May 26, 2017

TO : All Bidders
FROM : George M. Wiens
PROJECT : CTE Classroom Addition
1615400.41
SUBJECT : Addendum 1
DSA : 04-115755 / 33-H18

DRAWING NUMBER: **AW3.2**

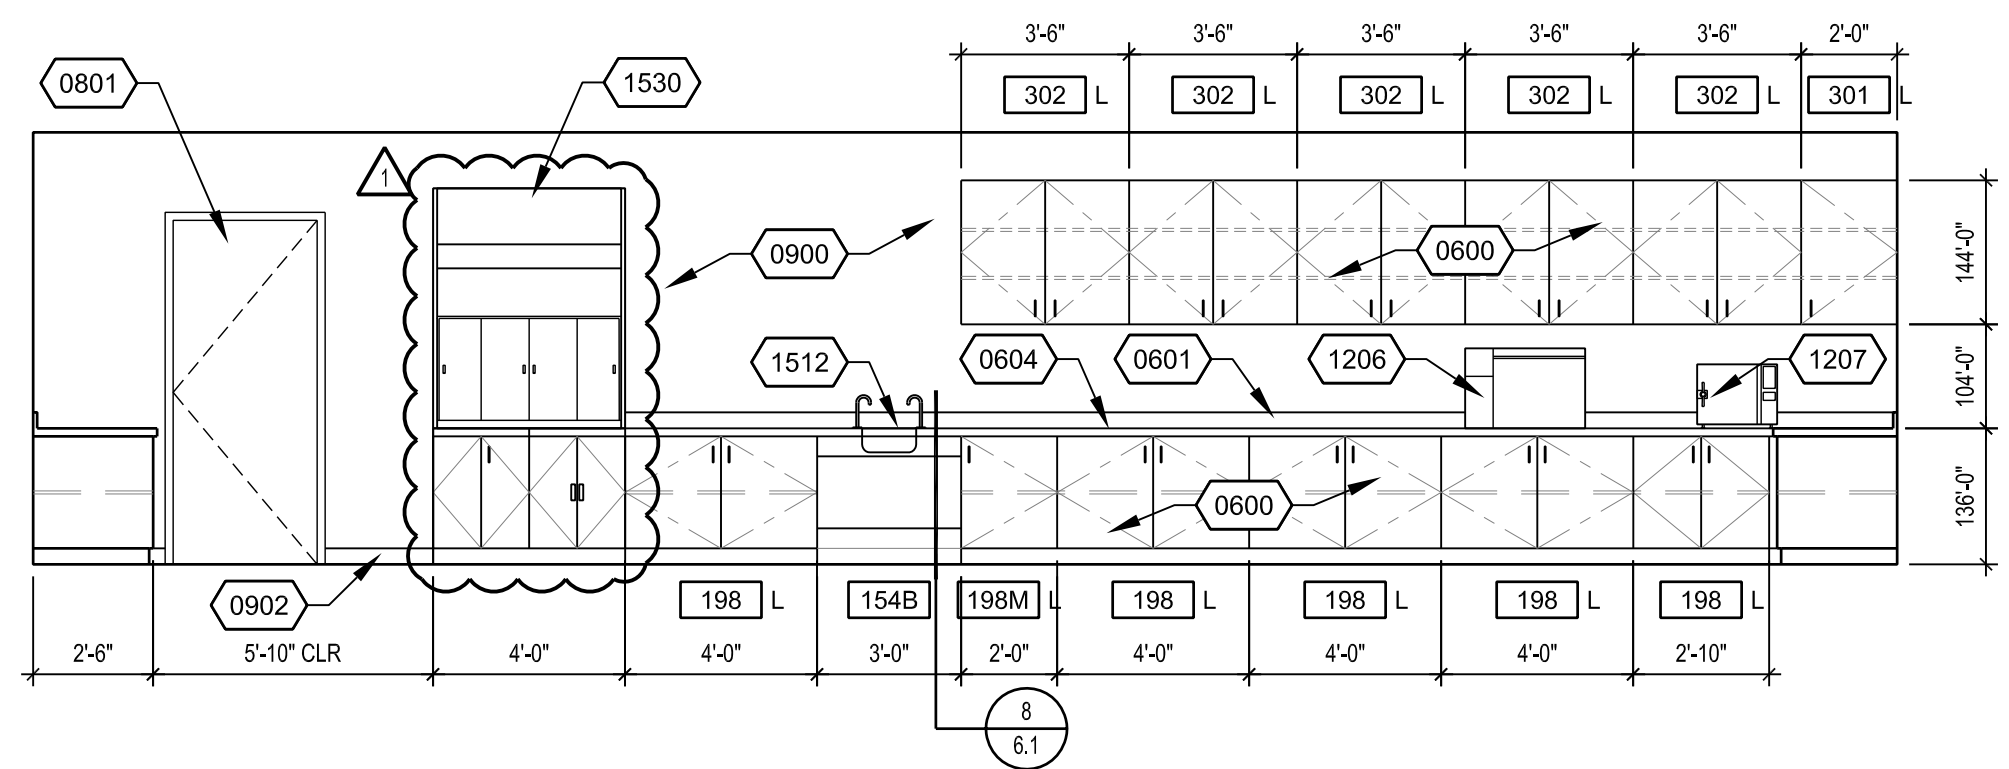
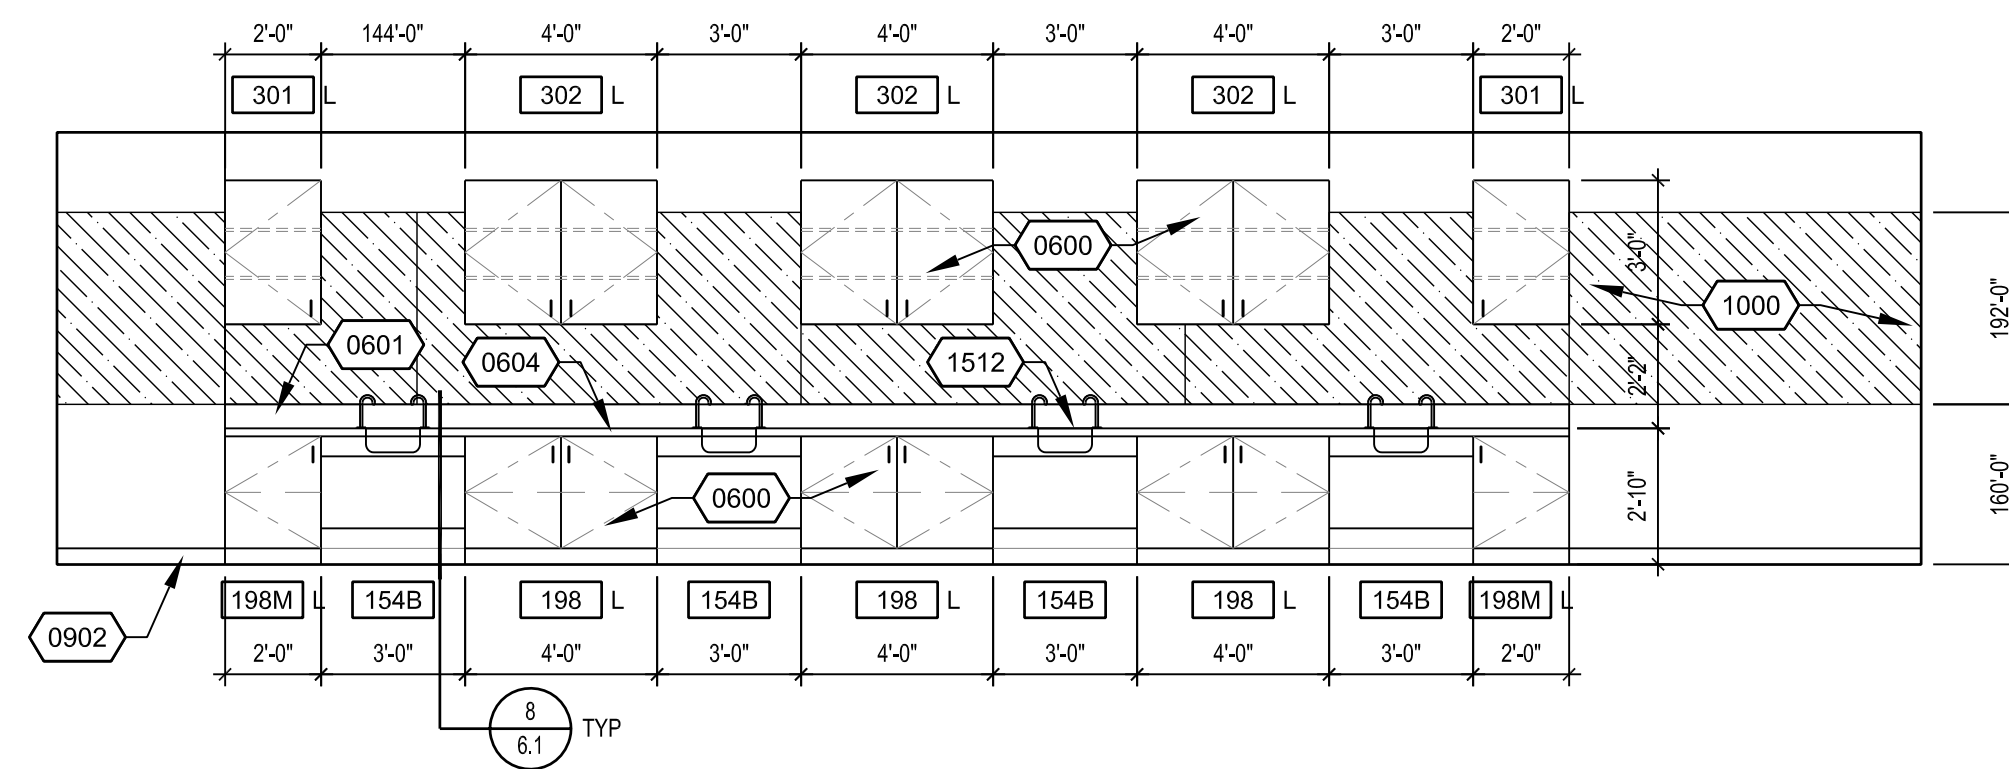
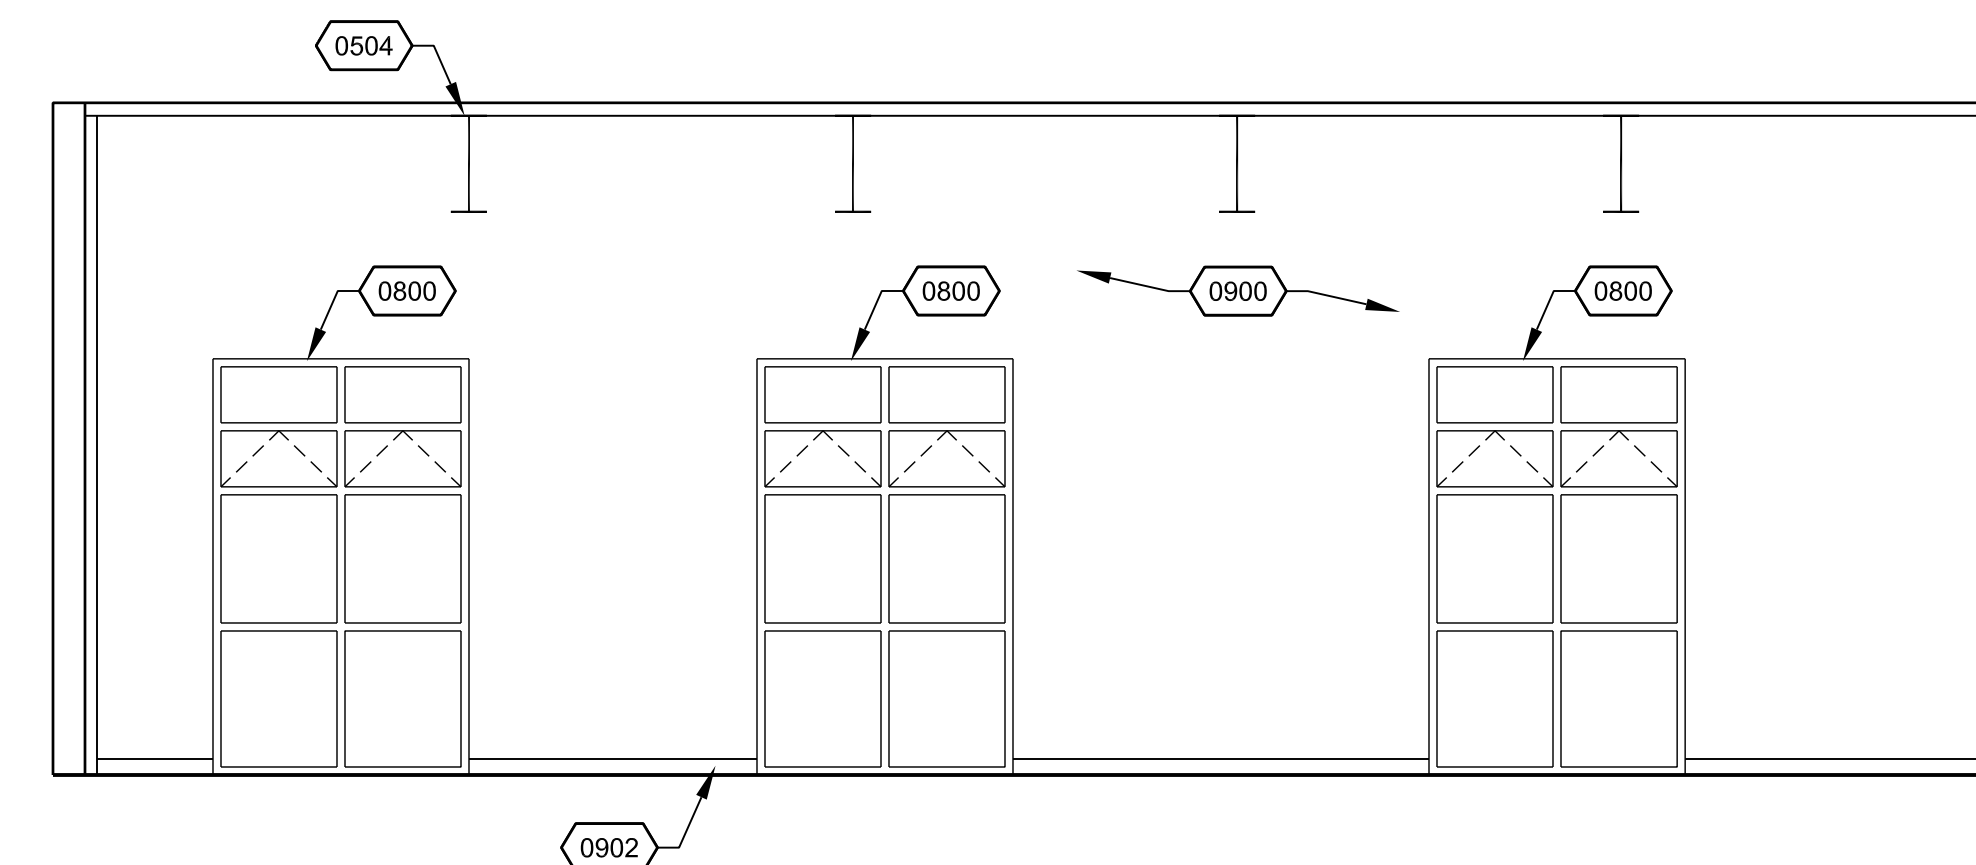
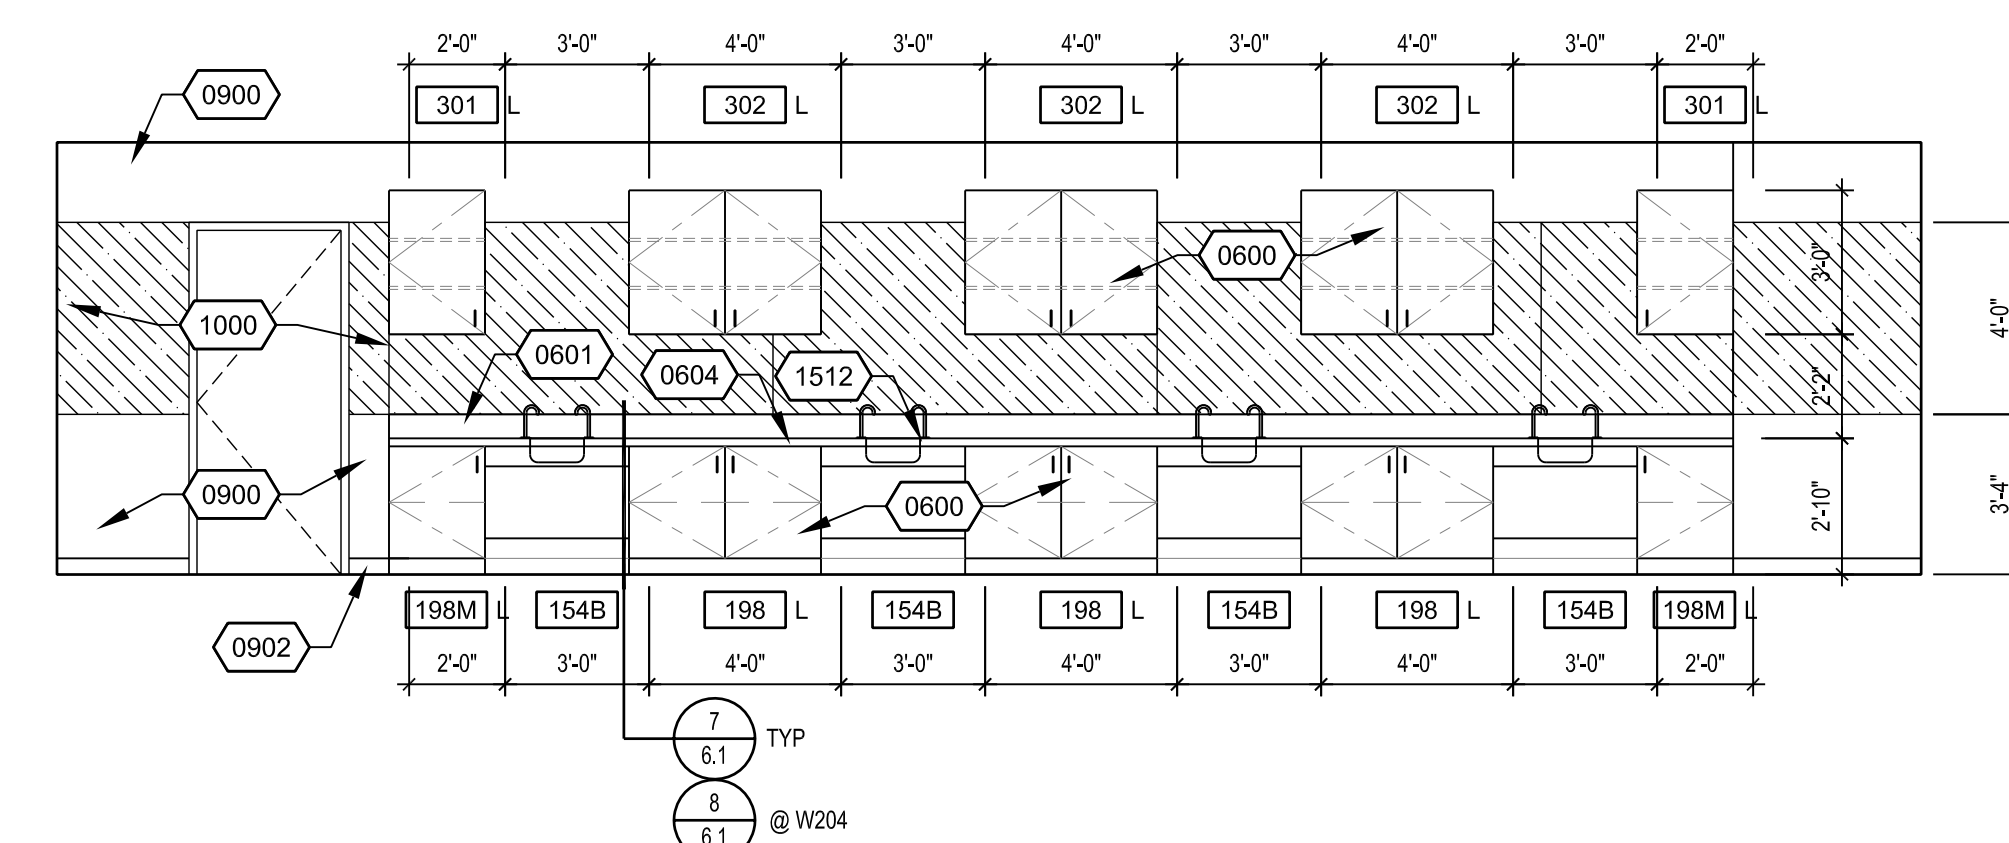
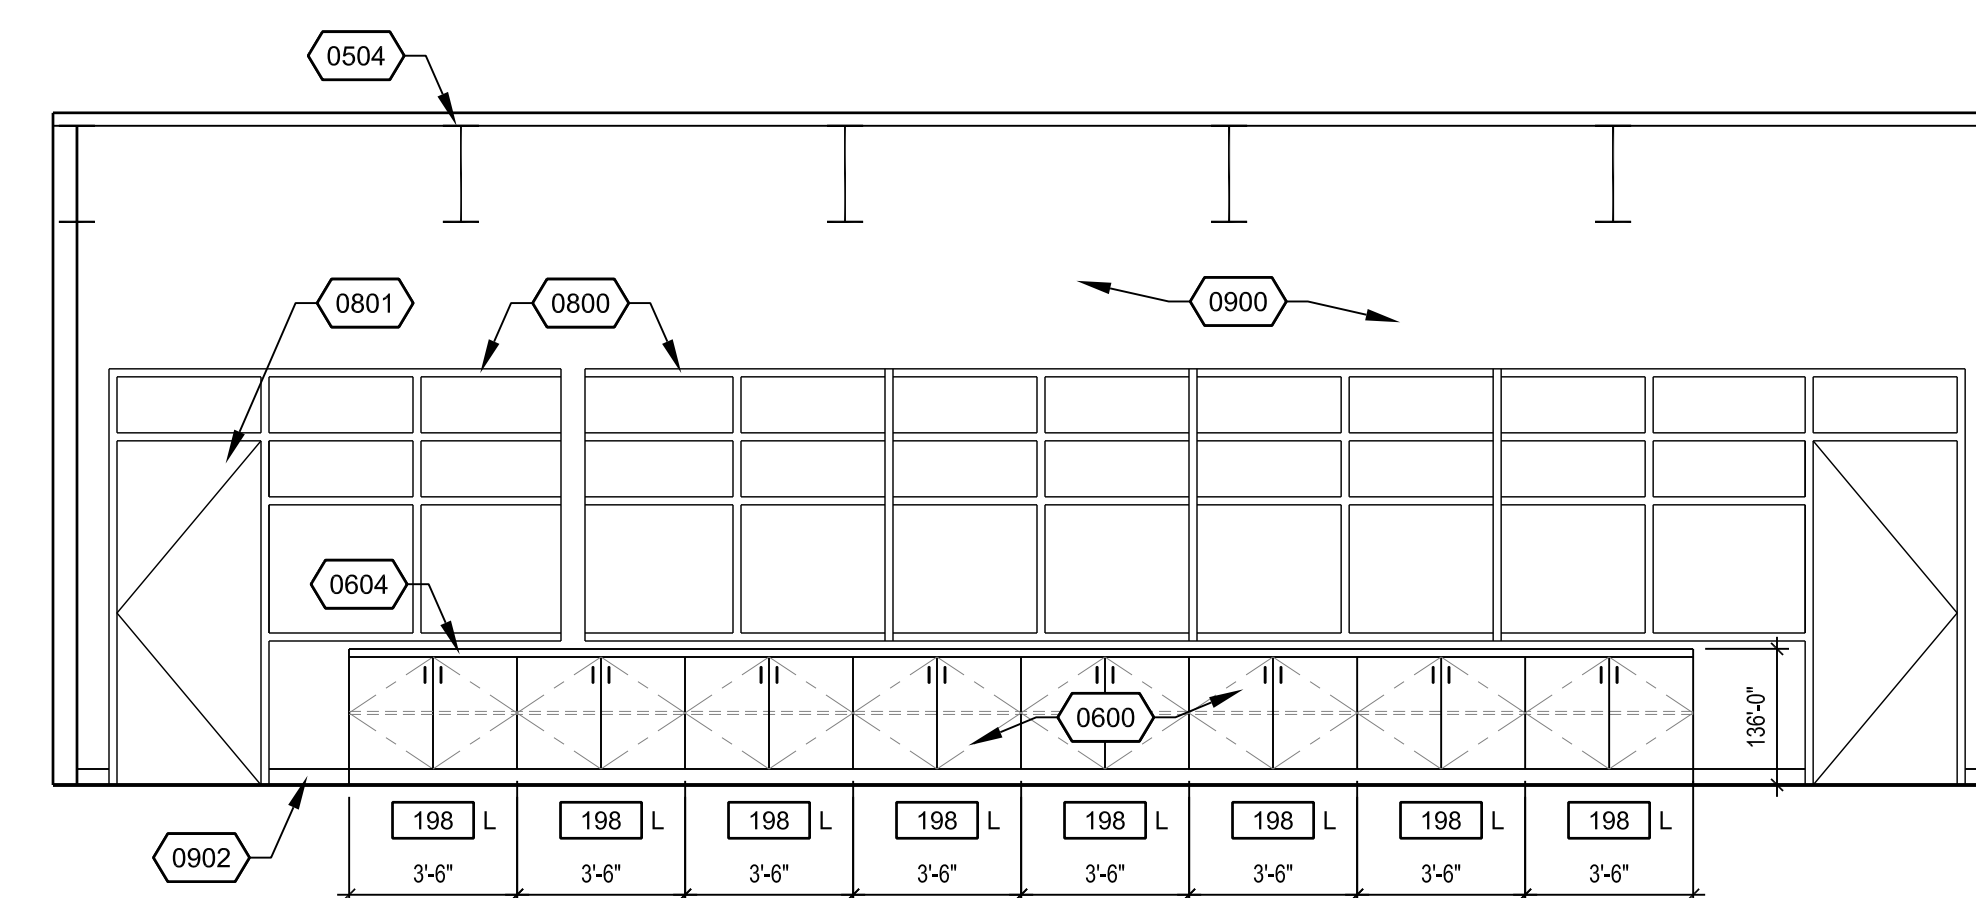
- A. Revise as indicated in the clouded area labeled Delta 1 on the attached AW3.2.
